Groundwater Sustainability Plan - Sustainable Management Criteria and Monitoring Network Chapters
Public Review Draft- Spring 2021
Compiled Public Comments, July 14 2021

Re: Comments to Draft Sustainable Management Criteria Chapter

Re: NOAA's National Marine Fisheries Service comments on the Draft Chapter 3 of the Groundwater Sustainability Plan for the Vina Subbasin

Enclosures

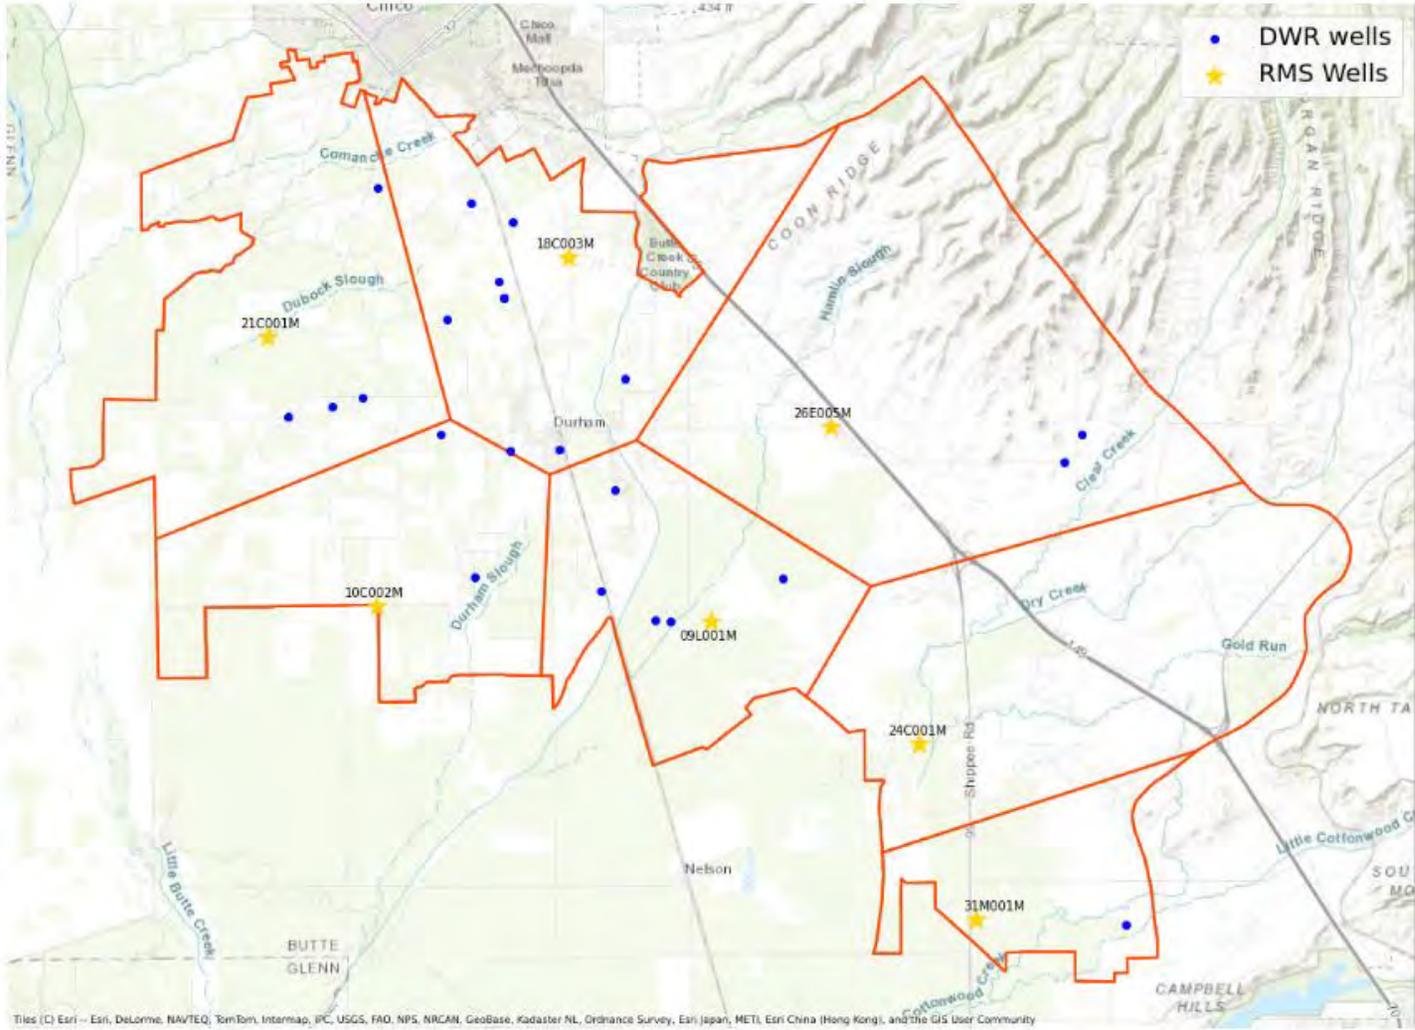
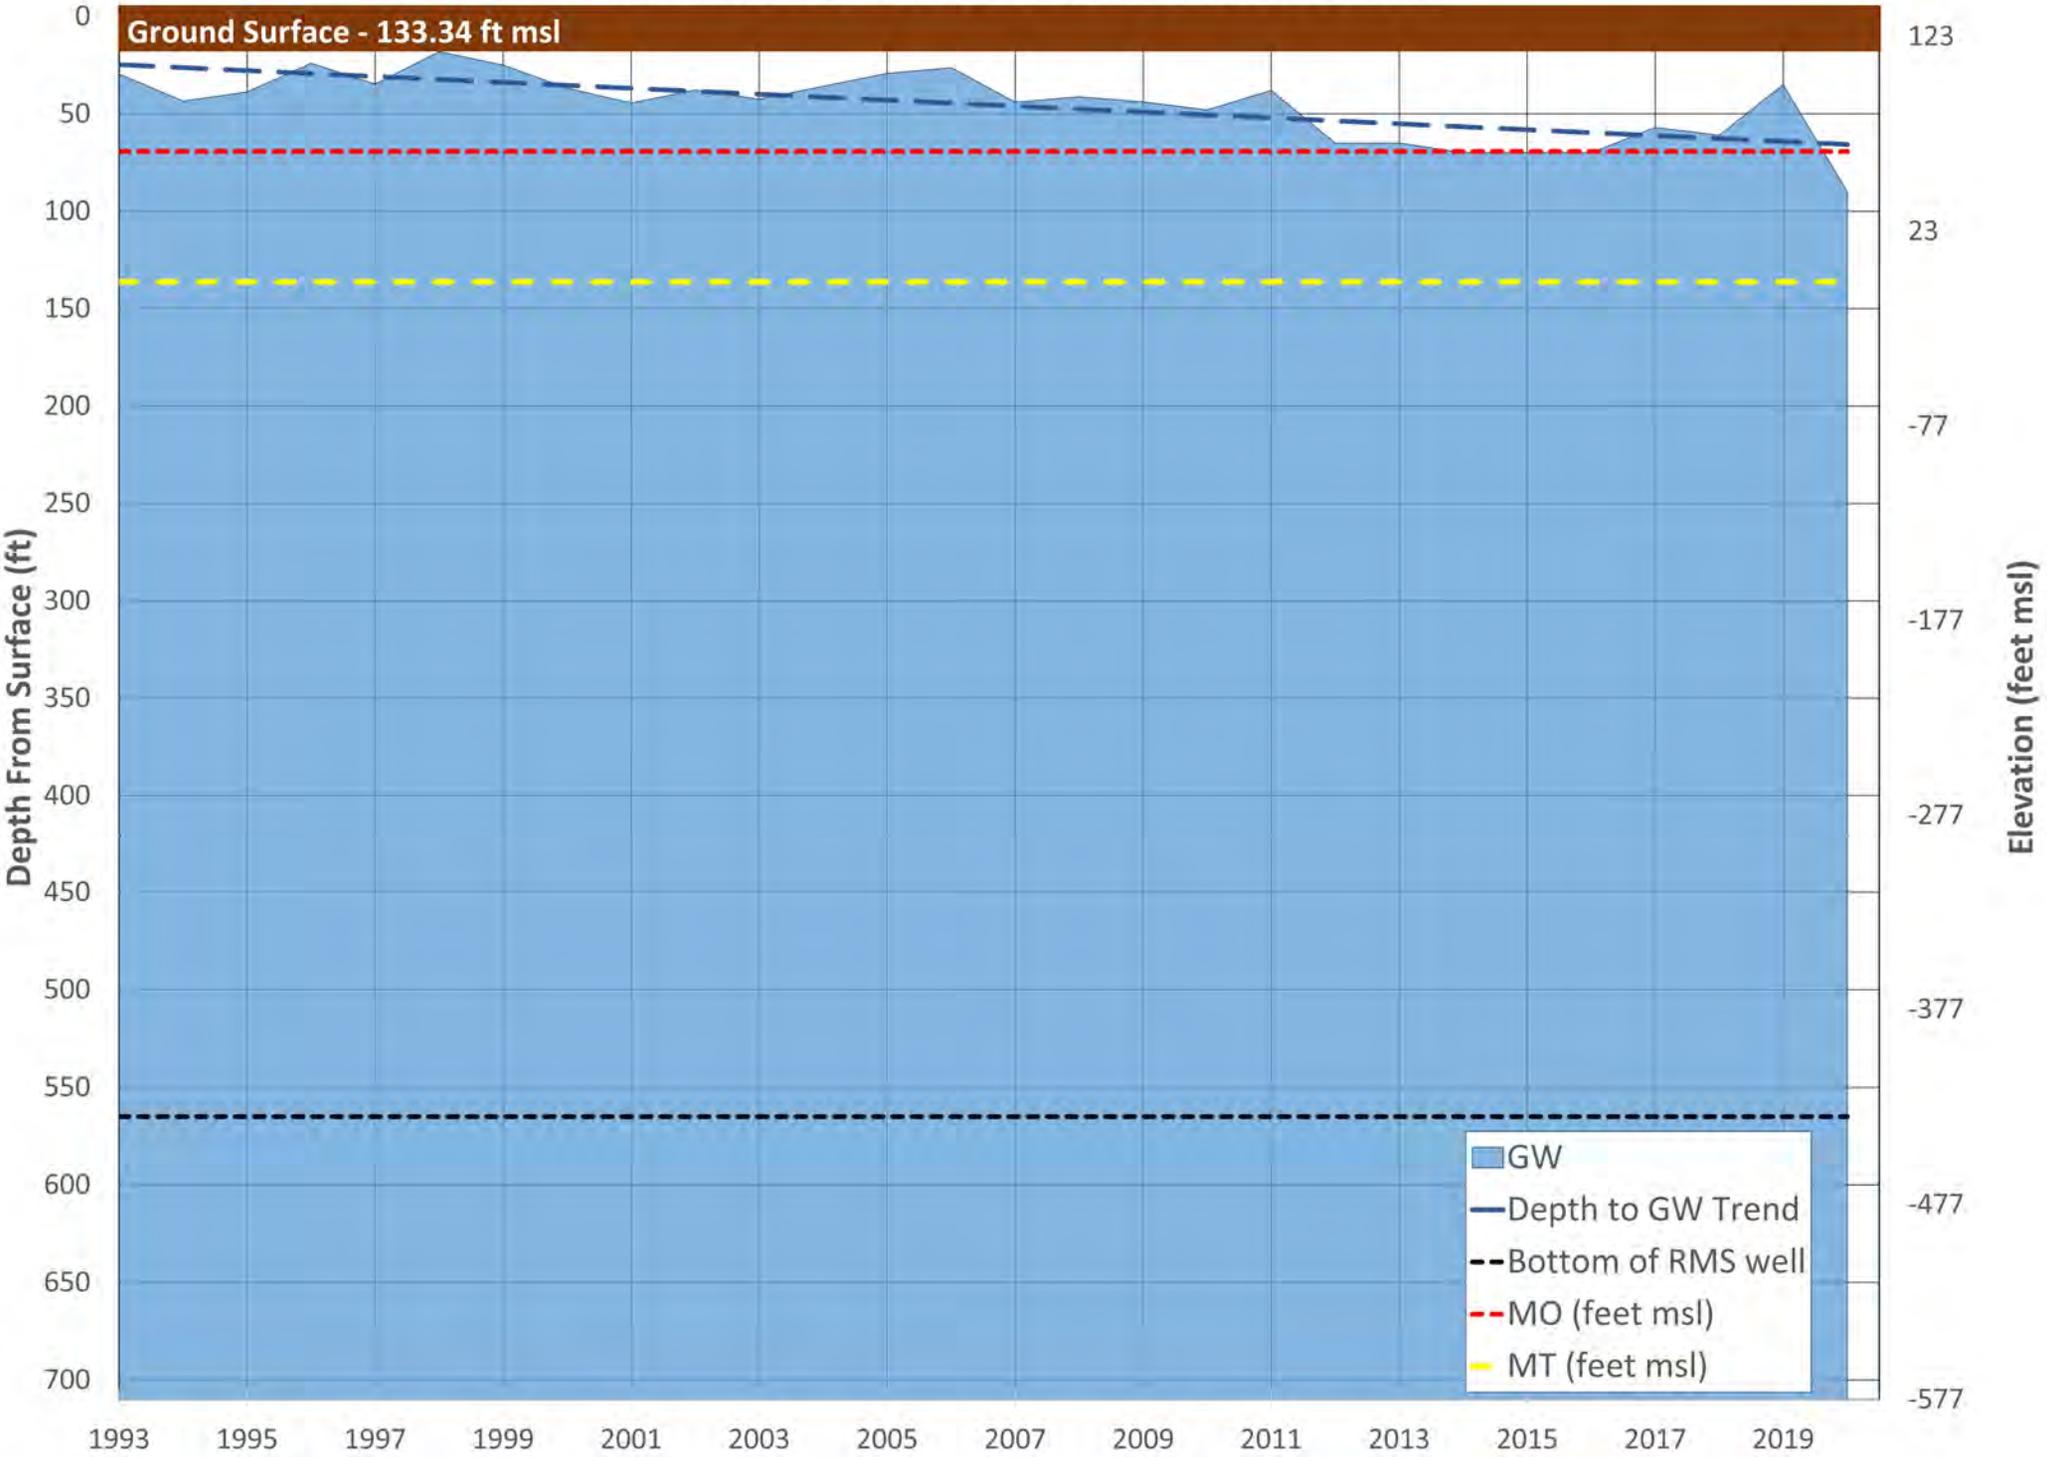
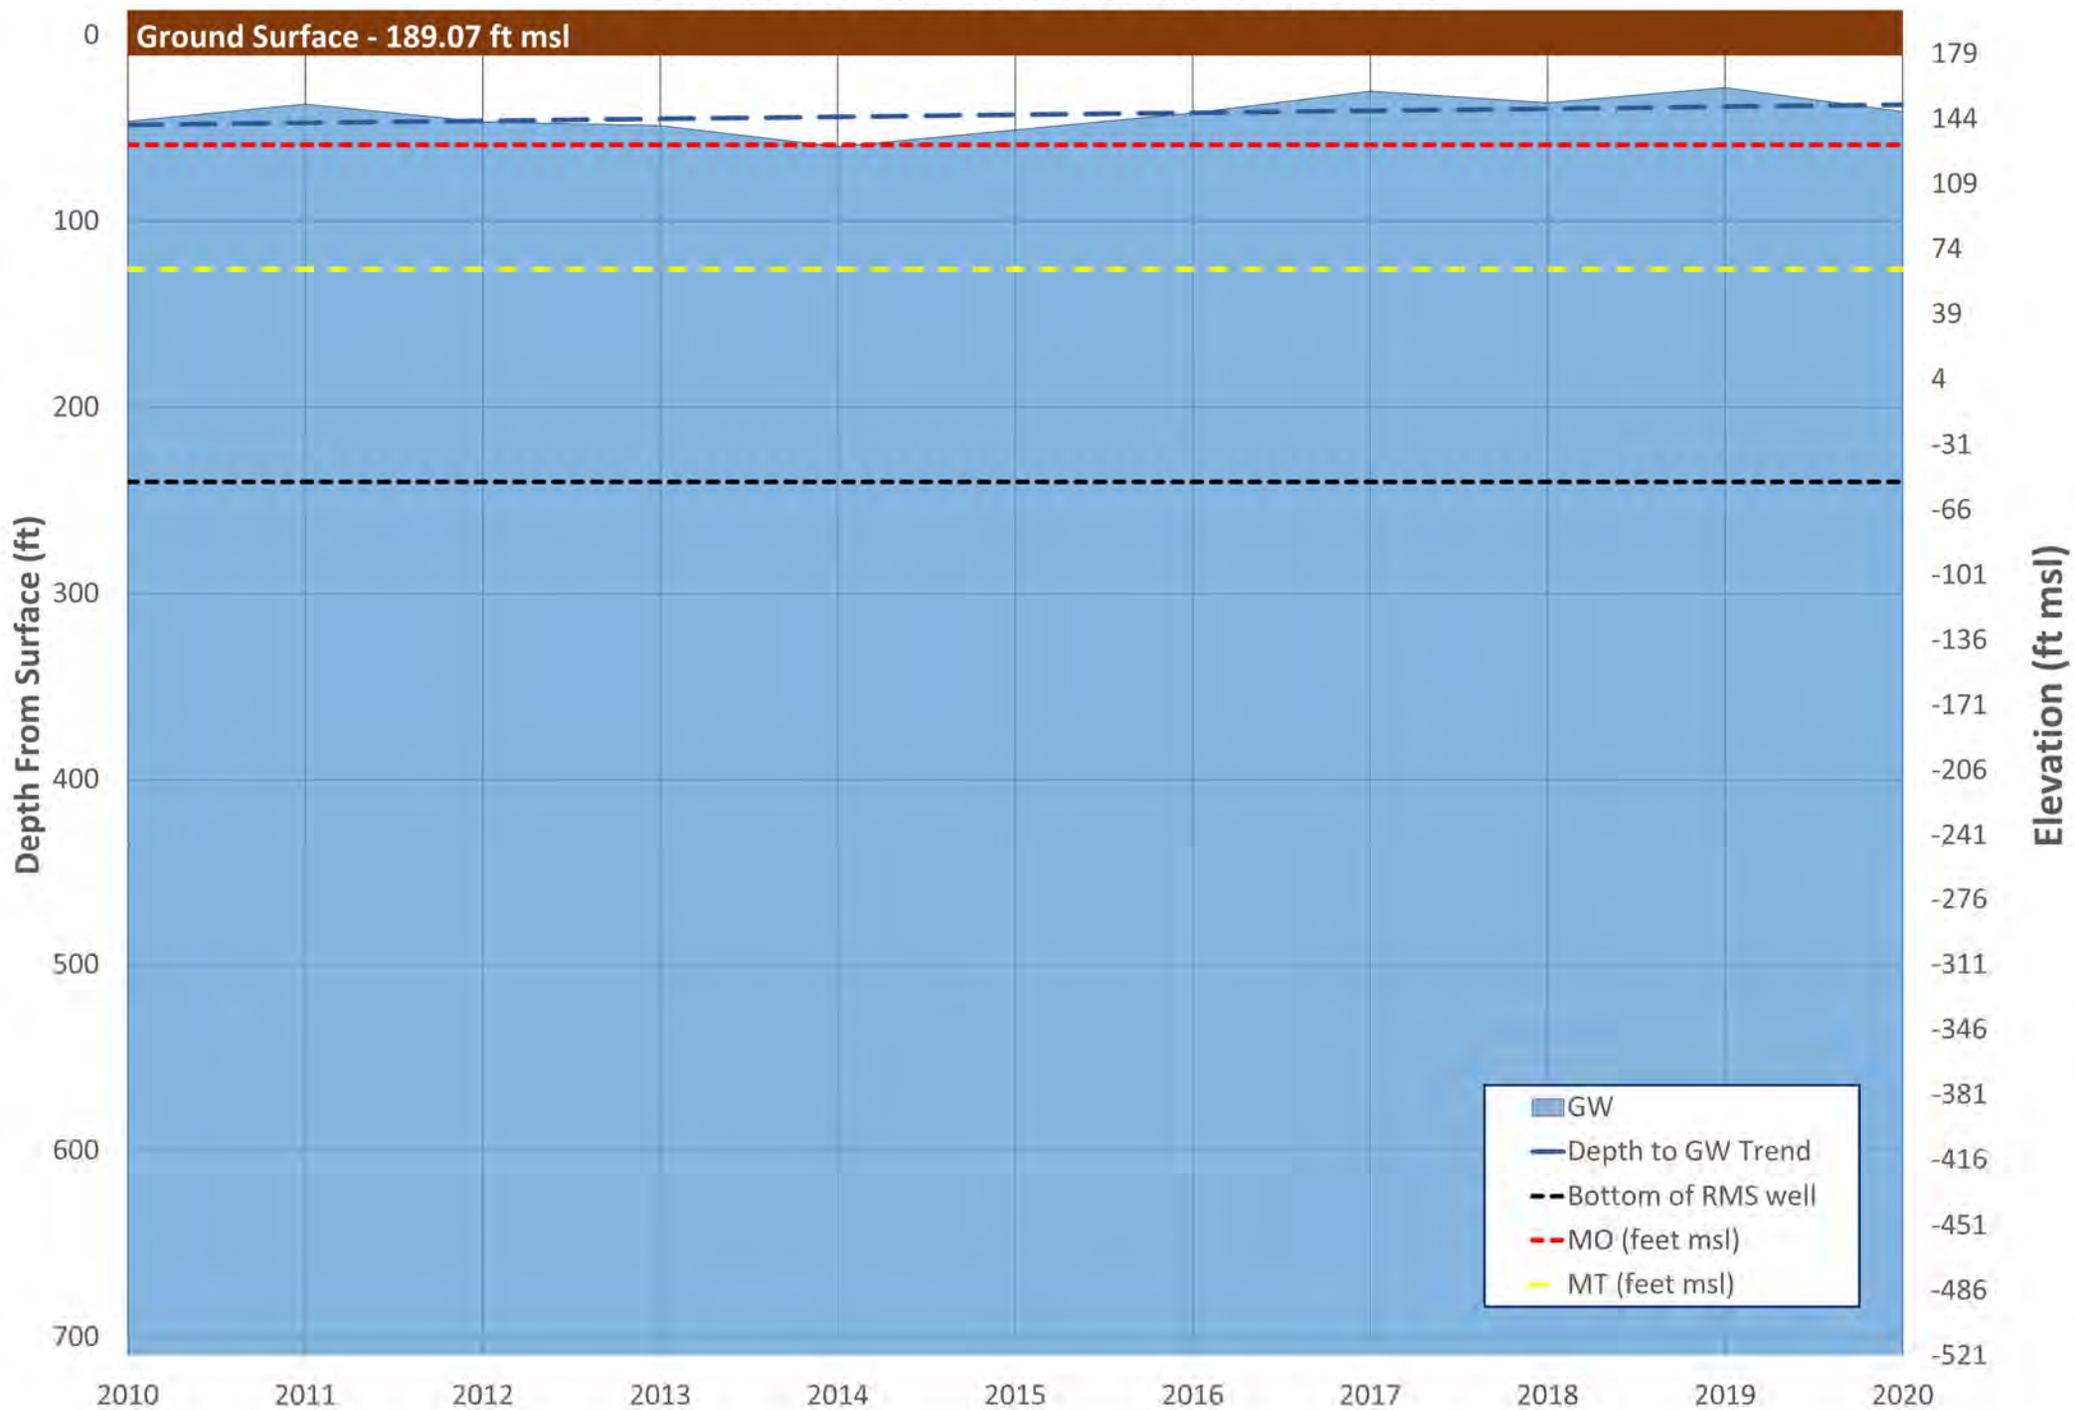
In recognition of the short timeframe to compile this information and meet the goal of the GSAs in getting the draft GSP out for public comment by September 2021, we hired Land IQ to propose polygons for the RMS wells in the Vina South Management Area. Enclosed is a map representing those polygons for the Vina South Management Area. You will find that a seventh zone is created as a result of this work.

The Margin of Operational Flexibility will need to be established for the polygon zones. As a starting point, we reviewed the Measurable Objectives (MO) and MT established for the Vina North Management Area and concluded that the average differential between the MO and MT was 67 feet. Consequently, the attached hydrographs for each RMS well (and polygon zone) show a difference of 67 feet between the MO and MT for the Vina South Management Area.
